**Land at Pineapple Farm,  
Mulberry Road,  
Congresbury**

**Designers Response Report**

Report Reference 1814/3/A

### **STAGE 1 ROAD SAFETY AUDIT**

### 5.0 PROBLEM LOCATION PLAN

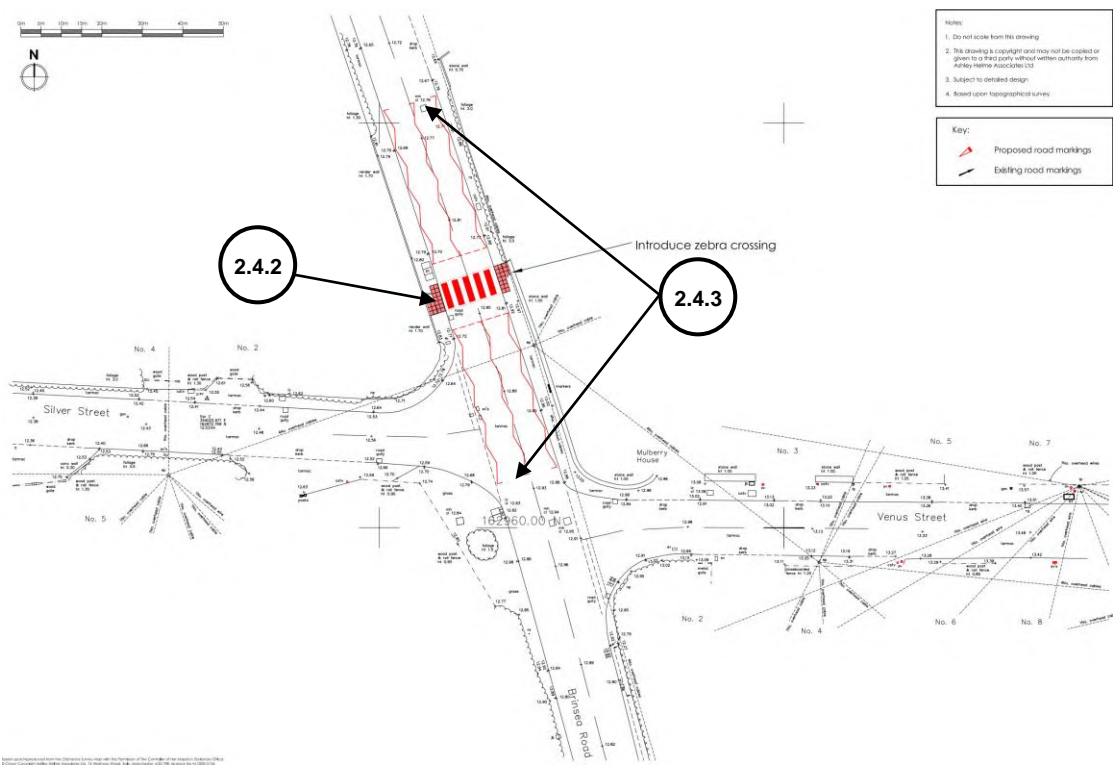
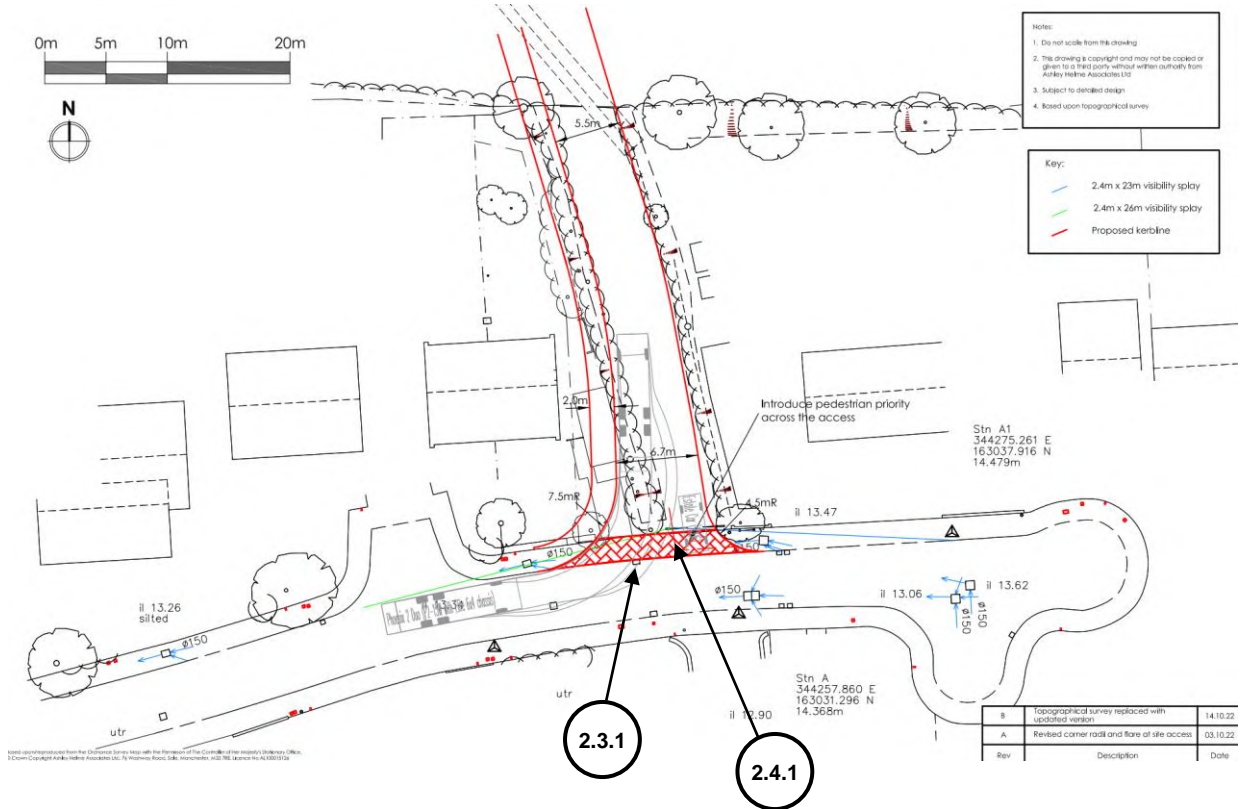
It was observed on site that there is an existing gully within the proposed junction on Mulberry Road. The location of the gully results in vehicles driving over the gully grate, which may result in the gully grate to become loose, rock or sink. This may increase the risk of loss of control collisions for those vehicles turning into/out of the new access who may encounter the gully. This issue is especially apparent for cyclists and motorcyclists.

The drawings provided for audit show that the proposed pedestrian crossing at the new junction on Mulberry Road will be a type where pedestrians have priority over vehicular traffic. It was noted during the site visit that all other pedestrian crossings across the junctions local to the proposed scheme have vehicular traffic priority over pedestrians. An inconsistent approach to pedestrian crossings in the locality may increase the risk of pedestrian/vehicular collisions, as drivers/pedestrian may fail to appreciate who has priority at the different types of pedestrian crossings.

It was observed during the site visit that the intervisibility between pedestrians crossing Brinsea Road from west to east at the proposed zebra crossing and drivers turning left out of Silver Street would be obscured by the adjacent hedge/wall of the corner property. A reduction of pedestrian/driver intervisibility may increase the risk of pedestrian/vehicular collisions as drivers approaching the crossing from Silver Street could fail to sufficiently appreciate crossing pedestrians and vice versa.

The proposed zebra crossing on Brinsea Road is located approximately 100m from the speed limit terminal point where the speed limit changes from 40mph to 30mph. There is a risk that vehicle approach speeds towards the zebra crossing may be excessive, especially on the northbound approach where drivers may not have sufficiently adjusted their speed. Excessive approach speeds towards the zebra crossing may result in it being difficult for crossing pedestrians to establish precedence over approaching vehicles, which may increase the risk of pedestrian/vehicular collisions. It is noted that the guidance set out in Local Transport Note 1/95 The Assessment of Pedestrian crossings, states that "Zebra crossings should not be installed on roads with an 85<sup>th</sup> percentile speed of 35mph or above".

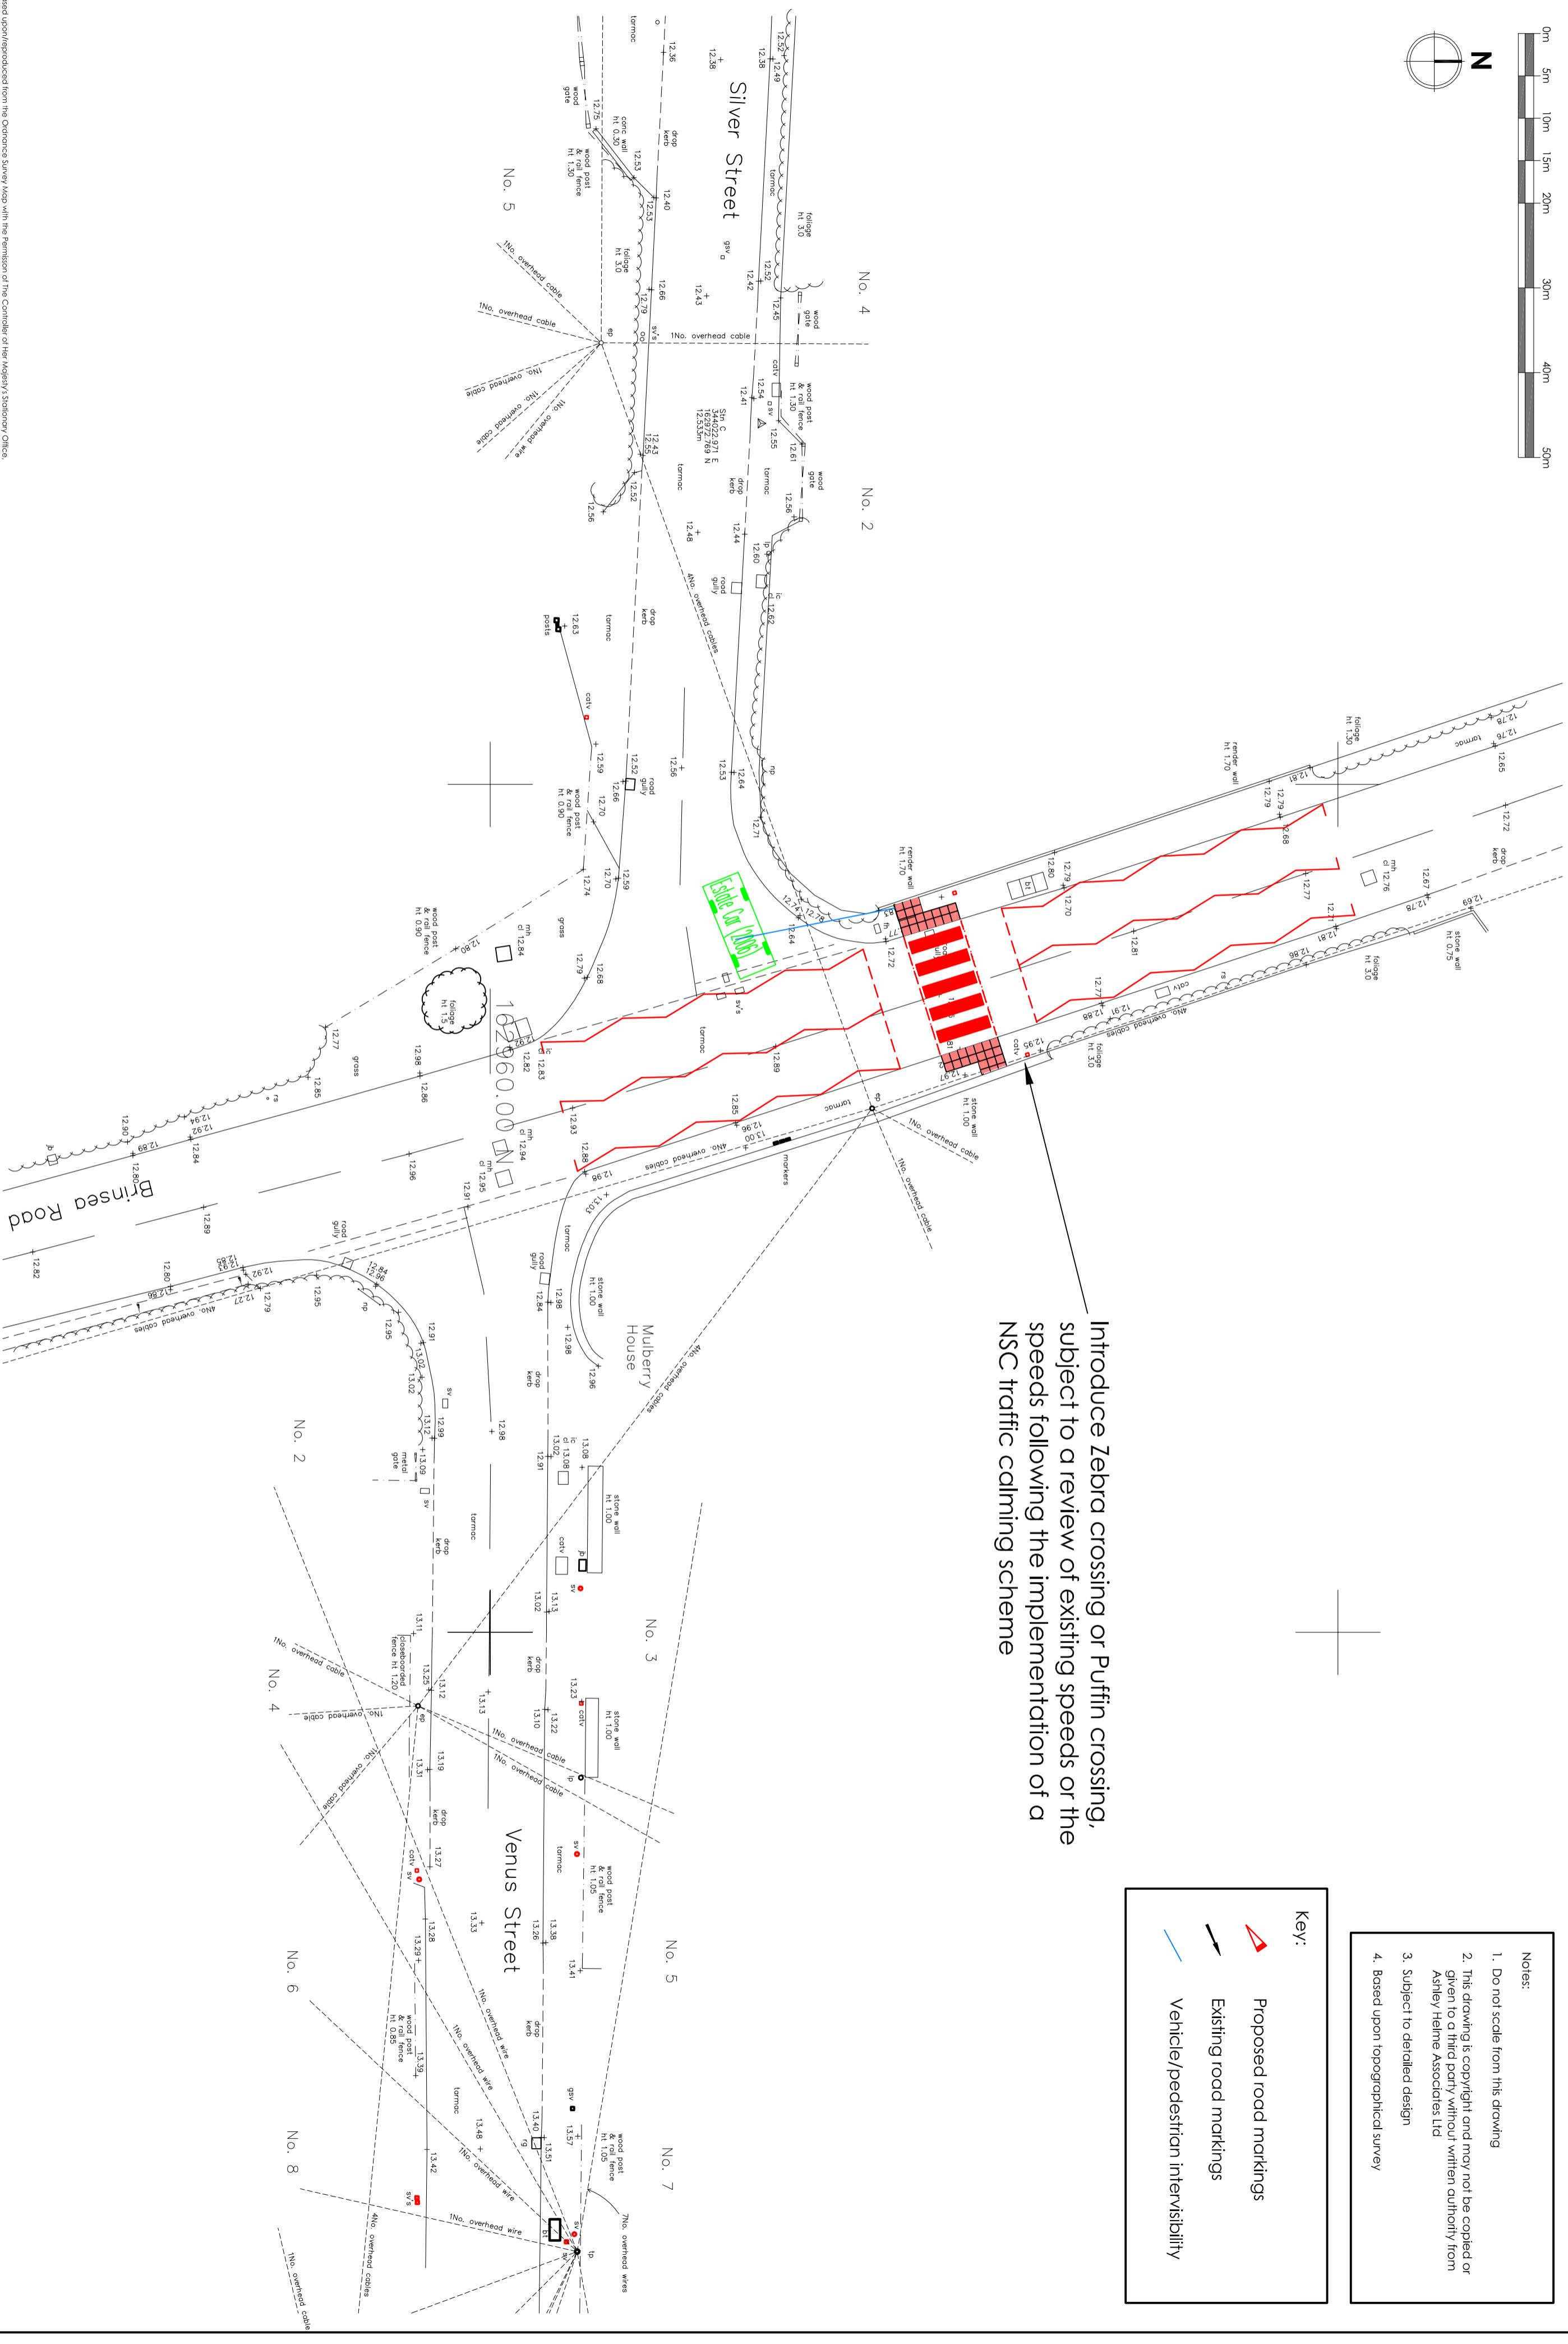
2.3.3 It was observed during the site visit that the intervisibility between pedestrians crossing Brinsea Road from west to east at the proposed zebra crossing and drivers turning left out of Silver Street would be obscured by the adjacent hedge/wall of the corner property. A reduction of pedestrian/driver intervisibility may increase the risk of pedestrian/vehicular collisions as drivers approaching the crossing from Silver Street could fail to sufficiently appreciate crossing pedestrians and vice versa.

- 2.4.3 The proposed zebra crossing on Brinsea Road is located approximately 100m from the speed limit terminal point where the speed limit changes from 40mph to 30mph. There is a risk that vehicle approach speeds towards the zebra crossing may be excessive, especially on the northbound approach where drivers may not have sufficiently adjusted their speed. Excessive approach speeds towards the zebra crossing may result in it being difficult for crossing pedestrians to establish precedence over approaching vehicles, which may increase the risk of pedestrian/vehicular collisions. It is noted that the guidance set out in Local Transport Note 1/95 The Assessment of Pedestrian crossings, states that "Zebra crossings should not be installed on roads with an 85th percentile speed of 35mph or above".

- 2.3.5.2 An alternative approach is to actually relocate the crossing nearer to Silver Street. Drg No 1814/01/A shows the crossing moved slightly closer to Silver Street and the inter-visibility between a car and the crossing. Provided the hedge is kept reasonably trimmed back, nearly all of the footway on the west side of Brinsea Road at the crossing point should be visible for a vehicle turning left into Brinsea Road from Silver Street. This should ensure that a pedestrian waiting to cross from the west side of the road should be visibility to a driver turning left out of Silver Street.

- 2.3.5.3 The issue of intervisibility between a vehicle turning left out of Silver Street and a pedestrian waiting to cross from the west side of Brinsea Road is acknowledged. It is considered that this issue can be addressed by either moving the crossing northwards or closer to Silver Street as shown on Drg No 1814/01/A. The exact location of the crossing can be determined at the detailed design stage. The details of the proposed NSC traffic calming measures along Brinsea Road may also influence the decision regarding the location of the pedestrian crossing and these should be known at the detailed design stage.

2.4.5.1 The Audit Team are probably unaware that NSC are currently looking at the options for the introduction of a traffic calming scheme on Brinsea Road. Therefore, it is likely that speeds on Brinsea Road will be reduced as a result of the traffic calming scheme. Notwithstanding this, a note has been added to Drg No 1814/01/A to state:

*“Introduce Zebra crossing of Puffin crossing, subject to review of existing speeds or the speeds following the implementation of a NSC traffic calming scheme.”*

Introduce Zebra crossing or Puffin crossing, subject to a review of existing speeds or the speeds following the implementation of a NSC traffic calming scheme
